CONSTRUCTION DRAWINGS FOX RUN NATURE CENTER

EPC STORMWATER REVIEW COMMENTS
IN ORANGE BOXES WITH BLACK TEXT

SHEET INDEX	
SHEET NUMBER	SHEET TITLE
C1	COVER
C2	EXISTING CONDITIONS & DEMO PLAN I
C3	EXISTING CONDITIONS & DEMO PLAN II
C4	SITE PLAN
C5	SIGNING & STRIPING PLAN
C6	DRIVEWAY & PARKING AREA GRADING PLAN
C7	BUILDING GRADING PLAN
C8	ROAD RECLAMATION GRADING PLAN
C9	WALL PLAN AND PROFILE I
C10	WALL PLAN AND PROFILE II
C11	WALL PLAN AND PROFILE III
C12	WALL PLAN AND PROFILE IV
C13	UTILITY SERVICES PLAN
C14	OFF-SITE WATER SYSTEM PLAN
C15	ON-SITE WATER SYSTEM PLAN
C16	OVERALL STORM SYSTEM PLAN
C17	ROOF DRAIN AND PATIO PLAN AND PROFILE
C18	POND PLAN AND PROFILE
C19	DETAILS

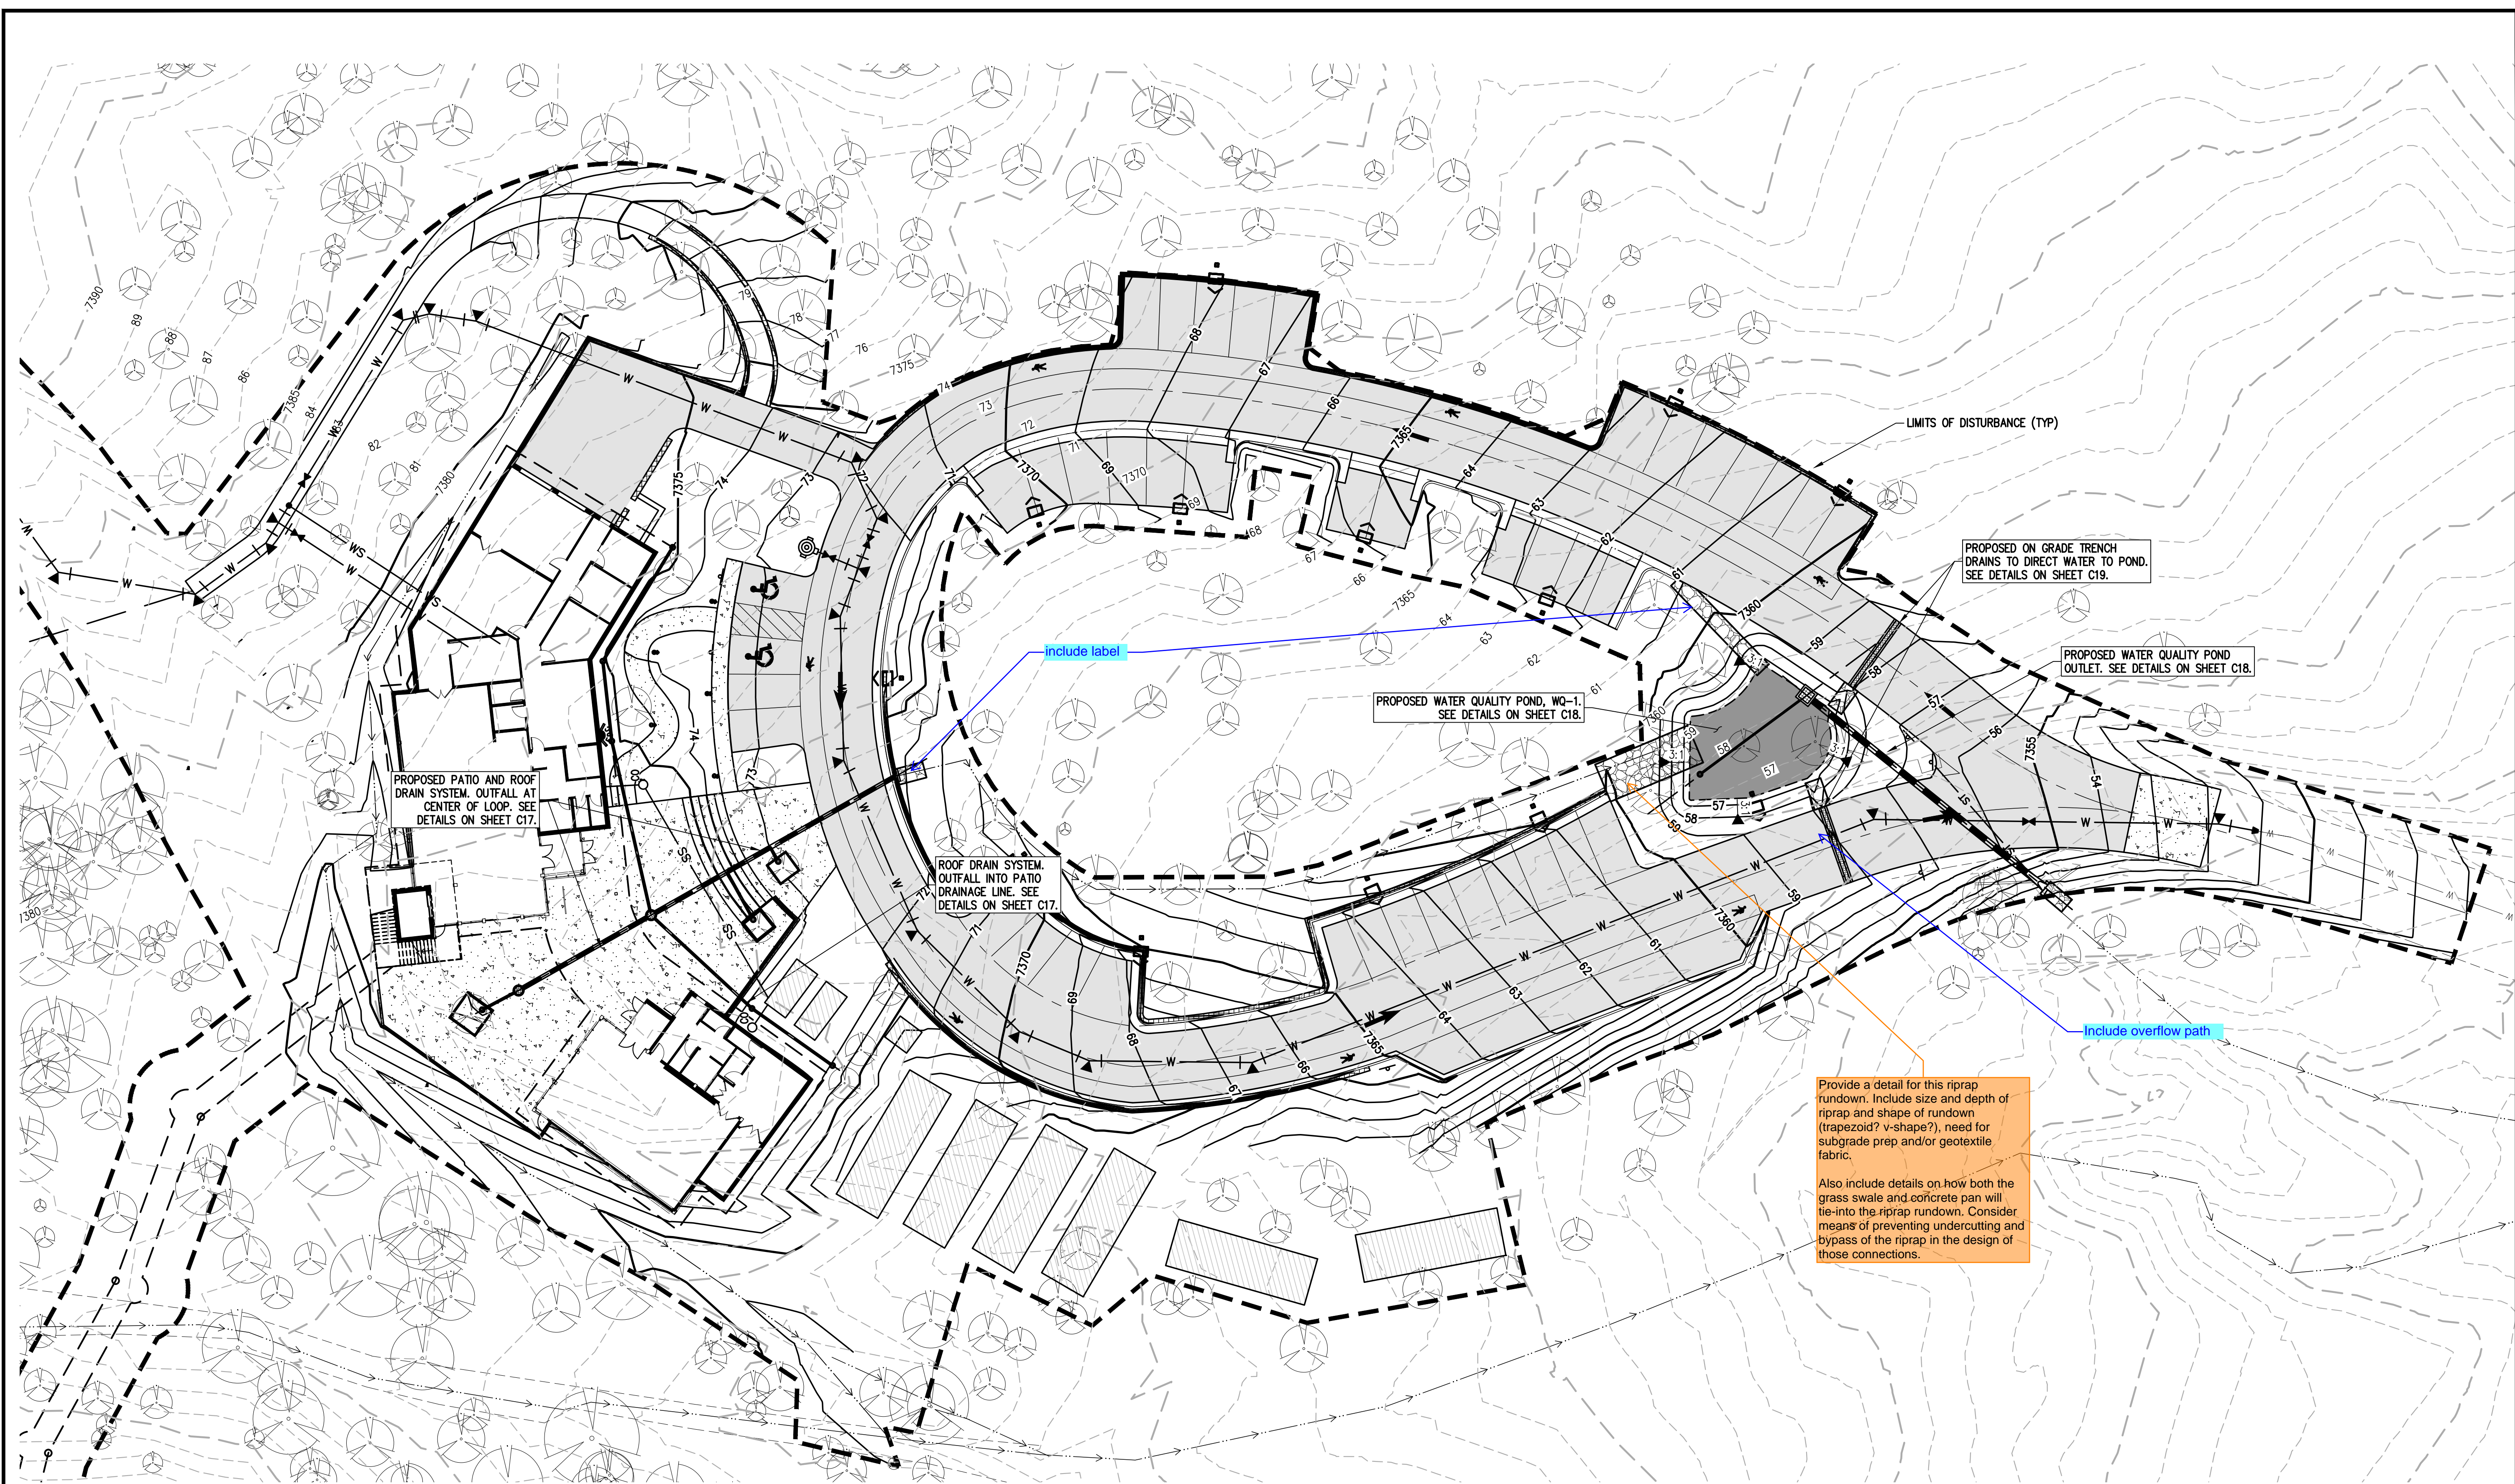
Please include all appropriate linework in the legend and turn off unneeded linework from this drawing

I don't see any rain garden specific vegetation requirements in the Landscape Plan. See my comments on Sheet C18 below for MHFD landscaping info for RG's.

RAIN GARDEN INLET WITH UPTURNED ELBOW

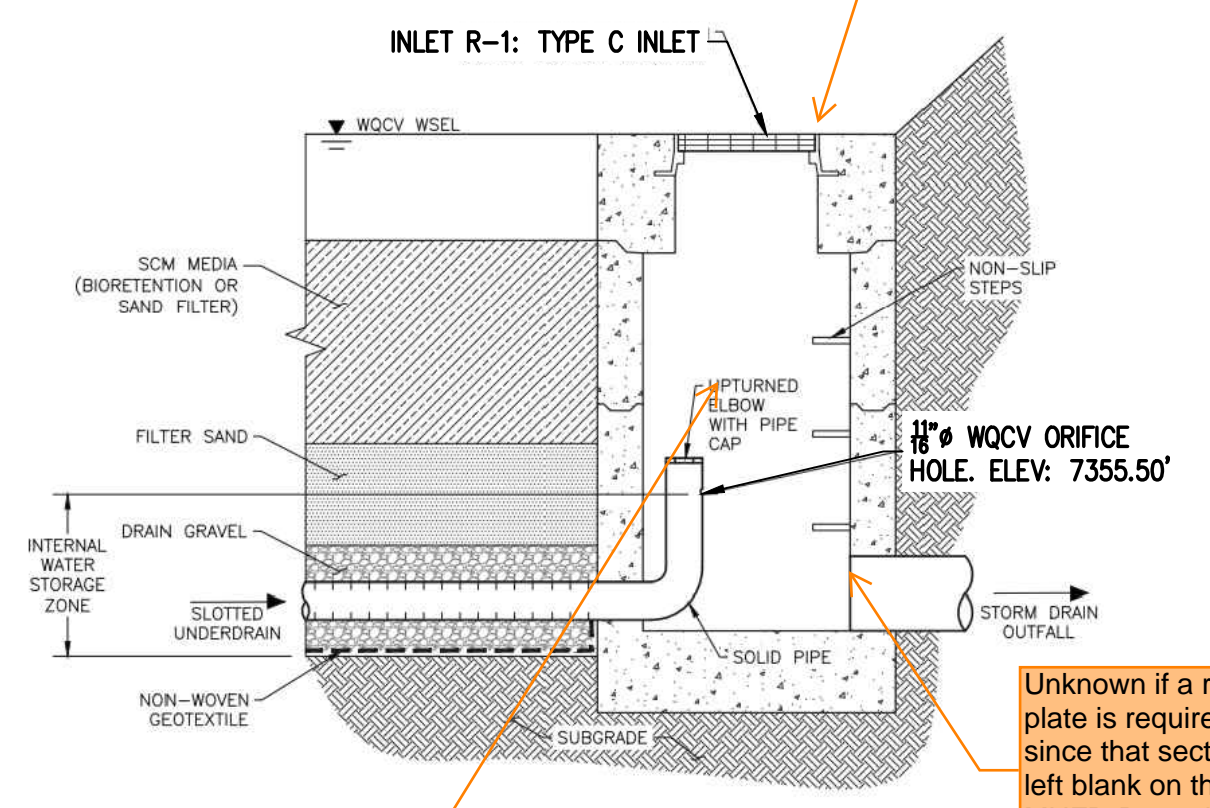
Provide a plan view of this inlet to show dimensions. Needed to compare to MHFD-Detention calcs.

Unknown if a restrictor plate is required here since that section was left blank on the MHFD-Detention calcs in FDR.

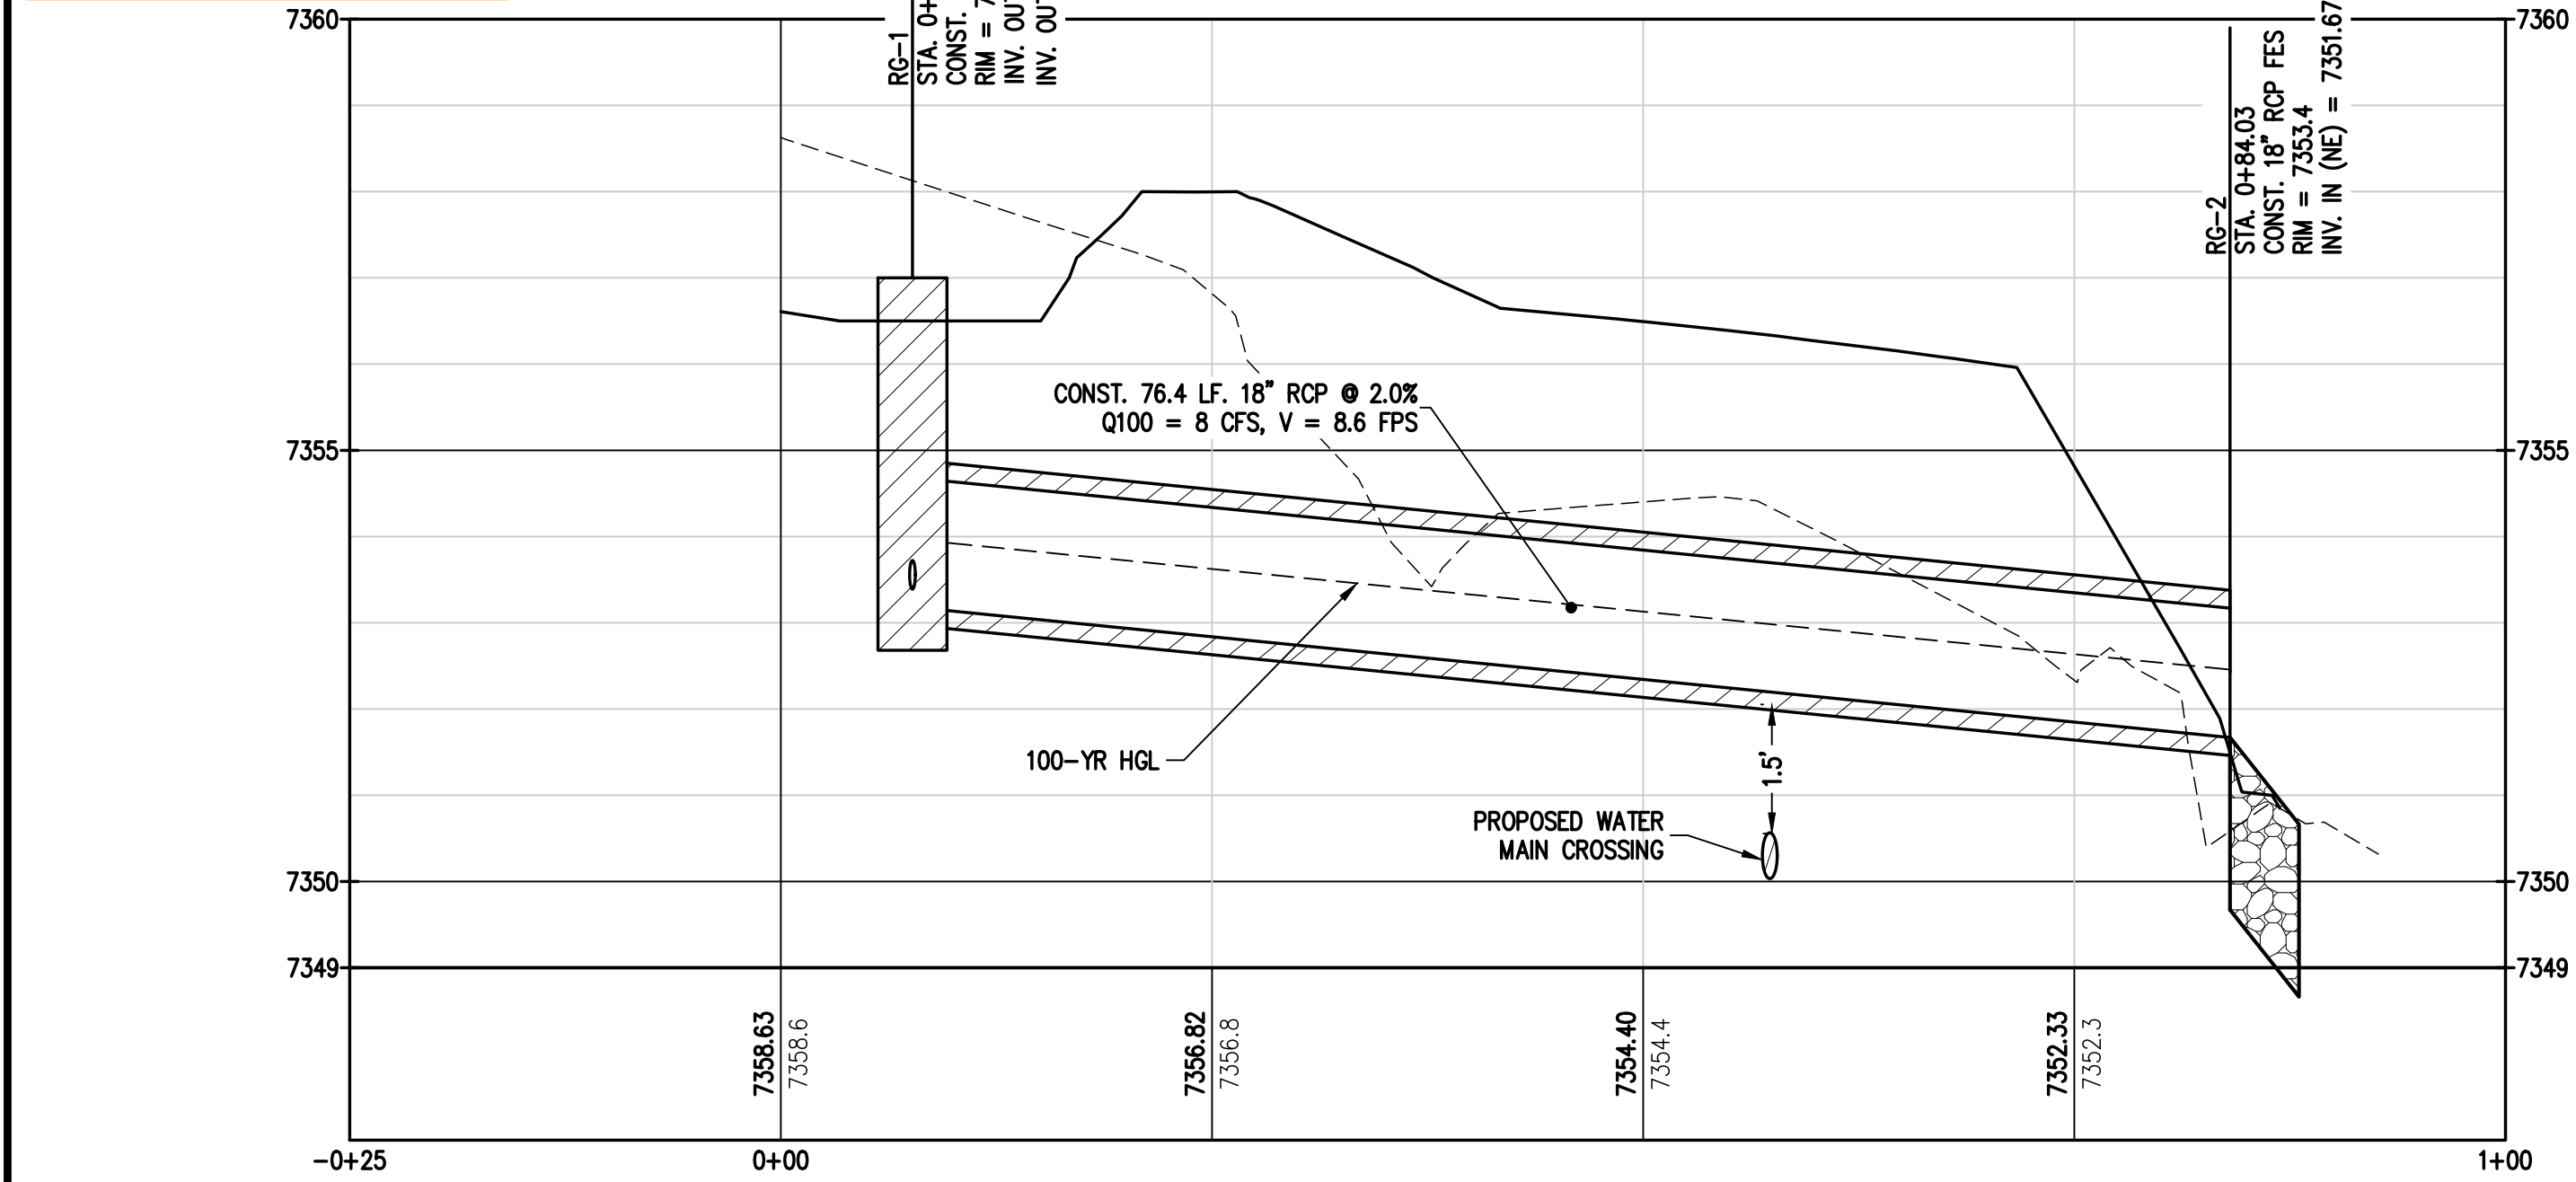
A detail is needed for these two inflow rundowns. I know that the contours shows the varying shapes of them, but the contractor needs to visually see that the top of the riprap is to be flush with the surrounding finished grade. We have seen riprap just dumped on top of finished grade, such that the rundowns are then susceptible to erosion/undercutting and don't function correctly either.

Please consider need for armoring of the spillway flowpath given the anticipated flows and velocities.

The section view from other side that was included with the last submittal was removed. That section is still needed to show how the underdrain is installed. Otherwise it appears that the drain gravel is to be installed throughout the entire pond bottom instead of just around the underdrain. MHFD section shown below for reference.

Specify depth of buried.

area does not match

Consider need to have all pond rundowns extend further into the pond bottom instead of just stopping at the toe of the slope. This will provide some energy dissipation and help prevent erosion of pond bottom.

Provide a text callout for this. I know in the 300sf inflow rundown above you have stated that the callout is for "each concentrated inflow of RG" however, the area is obviously different for this inflow point, so that at least needs to be labeled on here.

add this linetype to legend

Provide a typical detail for this rundown. The other inflow rundowns at least show some v-shaping in the contours on this plan view. However this rundown does not have any shape to it. So it is unclear how it is going to carry any flow and not just be bypassed.

I don't think we'll be able to excavate the pond, install the underdrain & media, and have this tree live. Plus it is not good to have a tree and its roots next to an underdrain. So this tree will need to be removed.

Add a north arrow.

Please clarify via text and/or contours. I measure closer to 3,300sf of flat bottom to your 835sf.

I'd like to discuss pond maintenance access. Is this the best place to access? Assuming that there is not a curb at this location of the road. There is still 3:1 slopes though to get to the pond bottom though. Can this corner be graded to be less steep? Vehicle access is needed to properly maintain water quality ponds.

I am not familiar with an "upturned elbow". Is that just a descriptor of the orientation of the elbow for installation? Or is it a type of elbow? I know that "upturned" comes from the MHFD detail, but still needs to be clarified on these plans. Also, clarify that this is a 90 deg elbow.

Please add this note that is from MHFD's DCMv3 Chapter 4:

Partial and Full Infiltration Systems: For partial and full infiltration sections, scarify the subgrade to a minimum depth of 12 inches and level the surface. Provide only limited compaction, where necessary, to limit settlement of the SCM.

Note that MHFD has recommends for this media beyond just being Type A soils:
